Disability Access Audit

Eye
Nr Peterborough
Cambridgeshire

Sandie Burns
DIAL Peterborough
Kingfisher Centre
The Cresset
Bretton
Peterborough
PE3 8DX

15th August 2013

Layout of blister paving at a controlled crossing

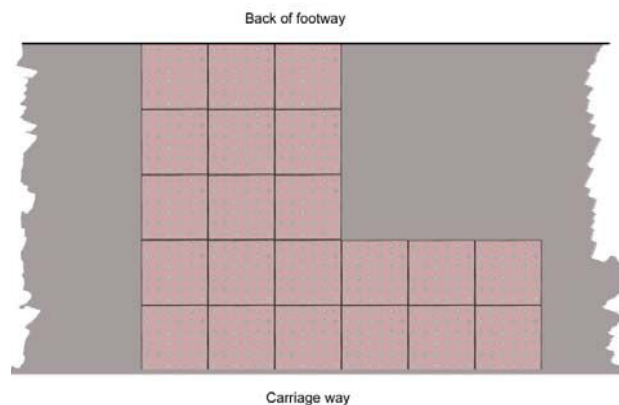
Ref	Observation	Recommendation	Priority
5.5	The zebra crossing outside the post office has not had its blister paving laid in accordance with guidance as this also uses guidance path paving. For controlled crossings, the blister paving should have a section leading to the back of the footway. The blister paving is red and so is the adjoining block paving. At controlled crossings, the blister paving should be red and contrast with the adjoining surfaces.	Provide blister paving to the zebra crossing as per guidance.	2

Dished gully used in the middle of the footway

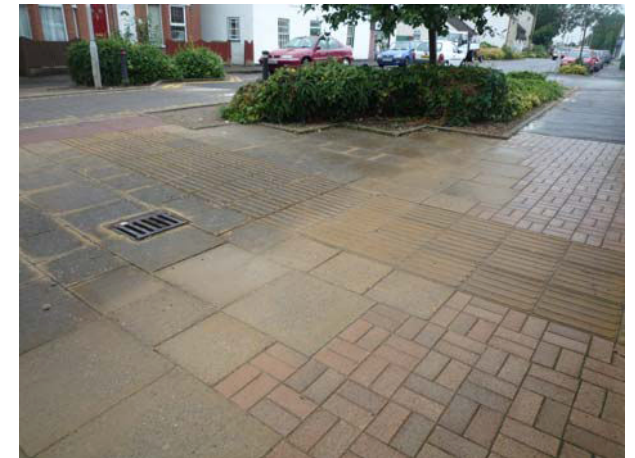
5.6	The surface is generally even and slip-resistant with the surface being made up of tarmac. However, towards the roundabout with Eyebury Rd/Thorney Rd/Crowland Rd, a half dished gully can be found within the pedestrian routes, this is not obvious and to visually impaired people and wheelchair users this could be an issue/hazard.	Look to replace half dished gully with a flush flat top gully	2
